Bulletin No.: PIT5307F

PIT5307F SES MIL / Service Suspension System / ABS MIL / No Crank / Misfire / A/C Inoperative (Inspect Engine Harness Chaffing At Vacuum Pump Pulley)

Product Investigation Review Required

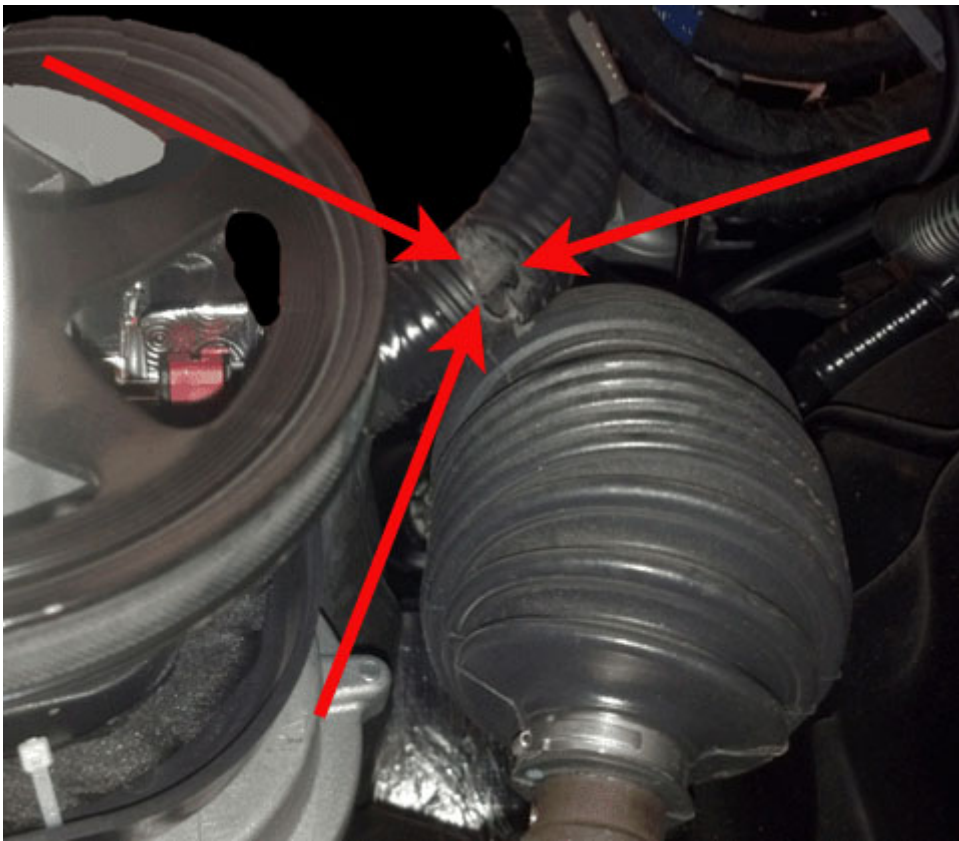
These issues could be caused by the engine harness rubbing on the engine vacuum pump pulley, as shown below.

Repair any damaged circuits, and resecure the harness away from the pulley to prevent the issue from reoccurring.
